19 May 2022
Our Ref: 20768C.3DK_S4.55(1A)

**RE: SECTION 4.55(1A) APPLICATION TO MODIFY
DEVELOPMENT CONSENT No. DA2020/0579 (AS MODIFIED)
25-27 WARRIEWOOD ROAD, WARRIEWOOD**

Figure 1 Location of the proposed landscape amendments

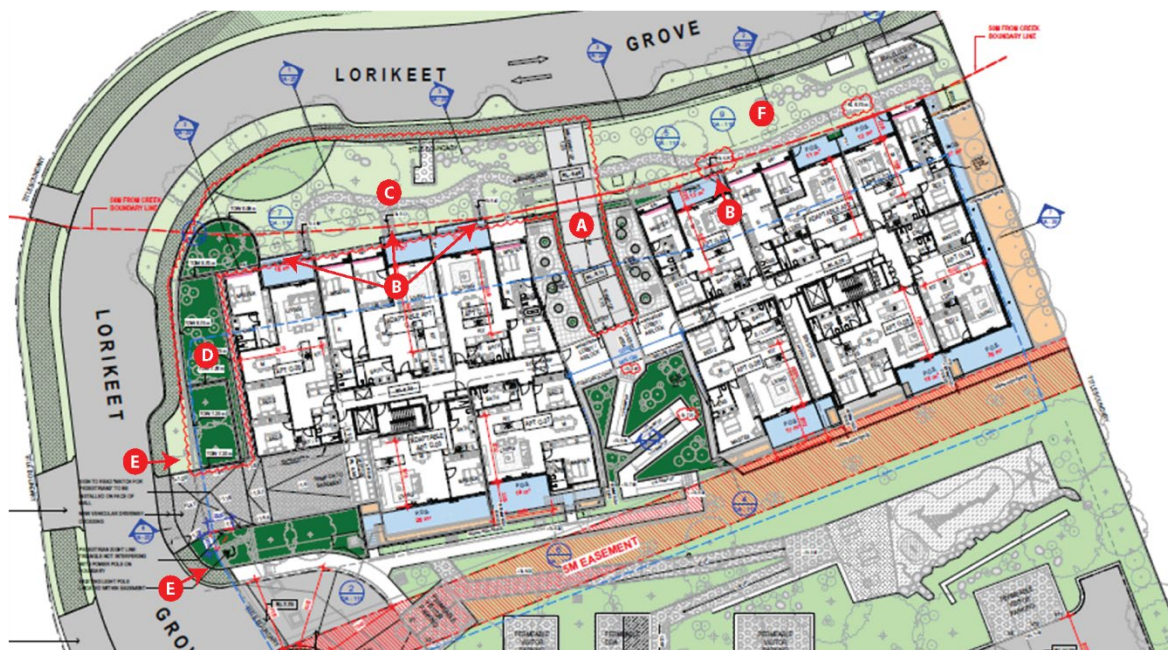
The plan modifications are labelled (A to F) on **Figure 1** and include:

- A. Reinstating the ramp from Lorikeet Grove to the southern apartment building.
- B. Reinstating the external steps to the ground floor dwellings of the southern apartment building and include a set of steps to Apartment G.01 that was inadvertently omitted from the plans in the original application
- C. Amending the landscape treatment of the western front setback to Lorikeet Grove to suit the amended finished ground levels associated with pedestrian ramp/path and steps.
- D. Amend the retaining wall arrangement along the southern setback to Lorikeet Grove (DA-200) to better integrate with the amended landscape treatment in the western setback and step the boundary planter wall to respond to the slope of the land/road. The approved plan DA-200 did not show the retaining wall and this has now been added. The wall height is a maximum of 1000mm.

- E. To correct an error on the landscape plans which indicated a planter with 1000mm soil depth on Council's verge either side of the basement driveway.
- F. To correct the plans to show the proposed fill and footpath levels in front of the northern apartment building.

Figure 2 Extract from southern elevation (DA-200)

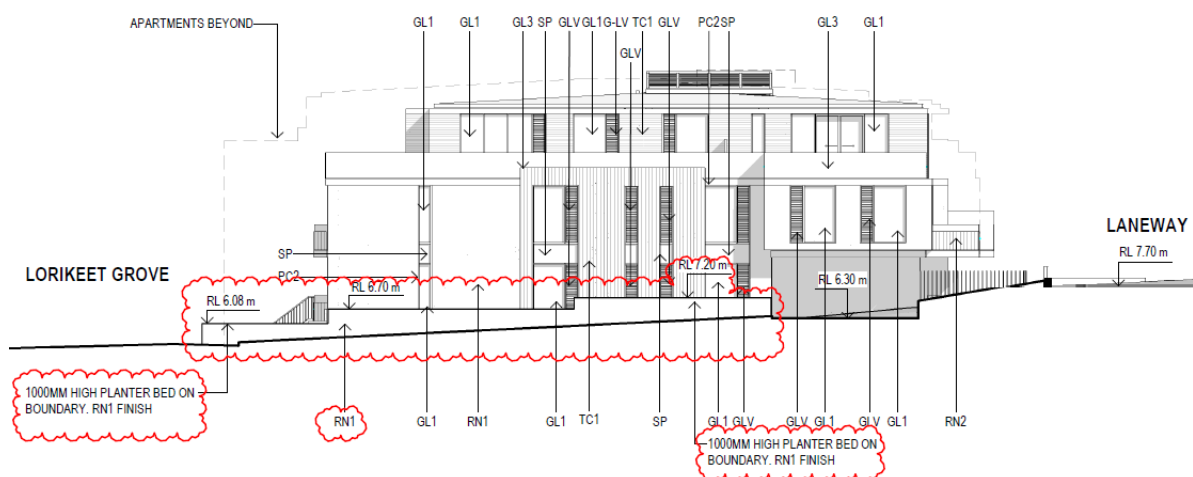
The retaining wall height was unfortunately not shown on the original plan. DA-200 now illustrates the retaining wall on the southern boundary which steps with the land.

The proposed amendment steps the retaining wall (refer to **Figure 2**) with a maximum external wall height of 1m. This will present a low scale wall to Lorikeet Grove.
